Response to: Consultation Response from KC Environmental Health – Pollution & Noise Control

Application: 2020/90450

Site: Land at, Owl Lane, John Ormsby V C Way, Dewsbury, WF12 7RQ

Proposal: Erection of restaurant with drive-thru, car parking, landscaping, play frame, customer order displays and associated works.

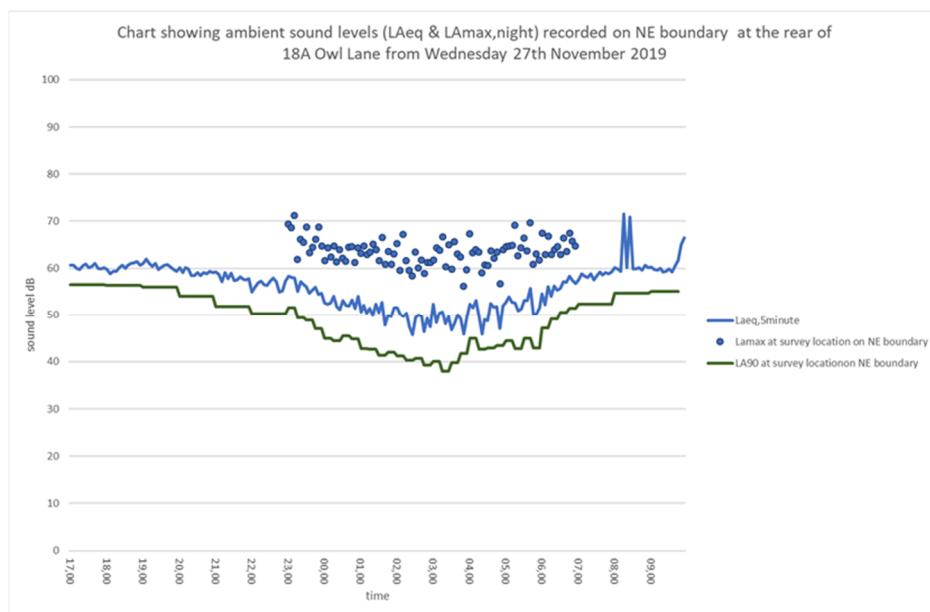
3. There is no accepted methodology for undertaking noise impact assessments for car park noise, customer vehicle noise, resulting in a variety of highly differing methods being used. The noise levels generated by the customer vehicle movements at the proposed development have been predicted in this instance, have been calculated by way of "the overall sound level created by a single vehicle, which will take approximately 2 minutes to arrive, order, collect and leave the drive thru lane, before being multiplied up for the number of vehicles predicted to pass through the drive thru lane in each hour, added to the number of vehicles using the car park". This has been used to predict an hourly LAeq,1hr. It appears that the customer vehicle (Activity) noise impact has been predicted by using the above Activity LAeq,1hr, and calculating the increase to the ambient noise climate.

- a. This method is not acceptable for the purposes of determining the noise impact of customer vehicles (due to the averaging time) – a more appropriate method would be to use the LAeq, T

(activity) for comparison, as this will provide a more accurate assessment of the actual noise impact at the nearby receptors. The use of LAeq,1hr hides the actual noise levels experienced.

It should be noted that methodology used for predicting the likely impact of the use of the drive thru lane and car park has been examined in detail at numerous Public Enquiries and none of these have found this, even when challenged by local authority's acoustic experts, to be "unacceptable".

When the restaurant is busy there will be a continuous procession of customer vehicles using the drive thru lane and coming and going from the car park across an hour and comparison of the noise created by these activities with that coming from the continuous traffic moving around the immediate road network of a similar period has not "masking" effort what so ever by the use of a 1 hour integration period. The impact assessment criteria set out in the report are based on using hours rather minutes.

To answer what noise level would a single vehicle using the drive thru lane create we know the SEL for this two-minute activity is 62 dB SEL (taken from 3rd Table at 8.1 of my report), or 41 dB LAeq,2minute.

The on-site noise survey revealed that the lowest recorded ambient level was 46 dB LAeq,5minute, see chart below;

The single customer using the drive thru lane would then increase the short term ambient level by no more than 1 dB ($41 + 46 = 47$ dB) and considerably less when the LAeq,5minute level was higher and it did rise to 53 dB in the hour up to 4am. A 1 dB increase, for the very worst case, cannot be described as a likely existence of an adverse impact.
